Engineering Change Notice

The following table contains a list of engineering changes that are not reflected in the Tsi381 Evaluation Board Schematics.

Tsi381 Evaluation Board Schematic

- PCI Arbitration PCI_GNT0#/PCI_REQ#0

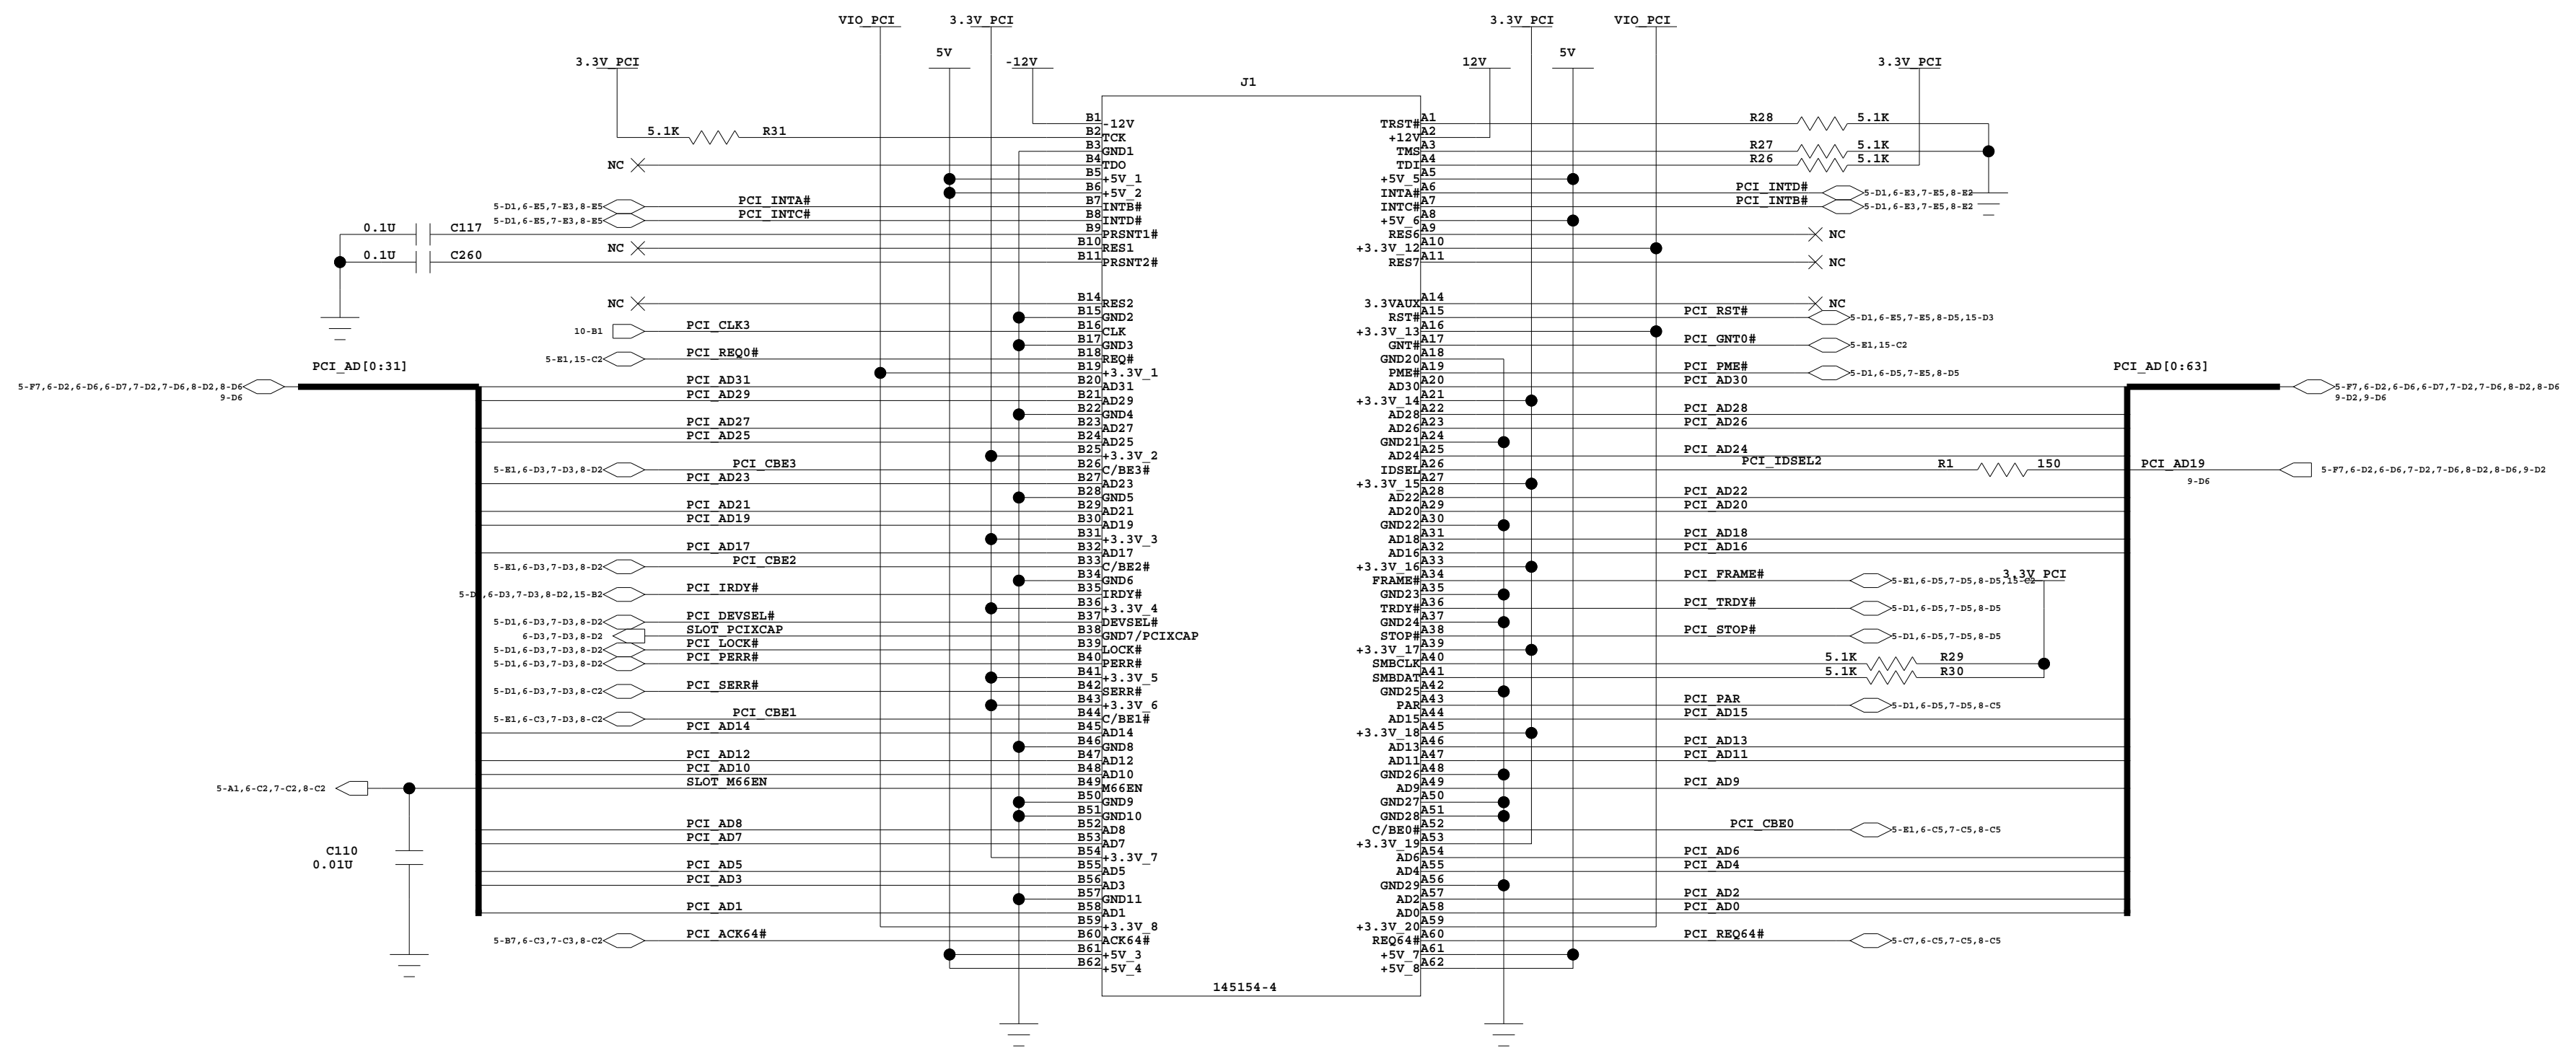
No.	Item(s)	Original	Change To
1	Tsi381 Device	Tsi381-66ILZ1	Tsi381-66ILZ2
2	3.3Vaux on J1, J2, J36, J37 ^a	No connection	Short pin A14 (3.3Vaux) to pin A16 (VIO_PCI) with 0-Ohm (0603) resistor

a. 3.3Vaux does not provide power to plug-in cards when the system is powered down.

No.	Item(s)	Original	Change To
1	Tsi381 Device	Tsi381-66ILZ1	Tsi381-66ILZ2 ^a
2	3.3Vaux on J1, J2, J36, J37 ^b	No connection	Short pin A14 (3.3Vaux) to pin A16 (VIO_PCI) with 0-Ohm (0603) resistor

b. 3.3Vaux does not provide power to plug-in cards when the system is powered down.
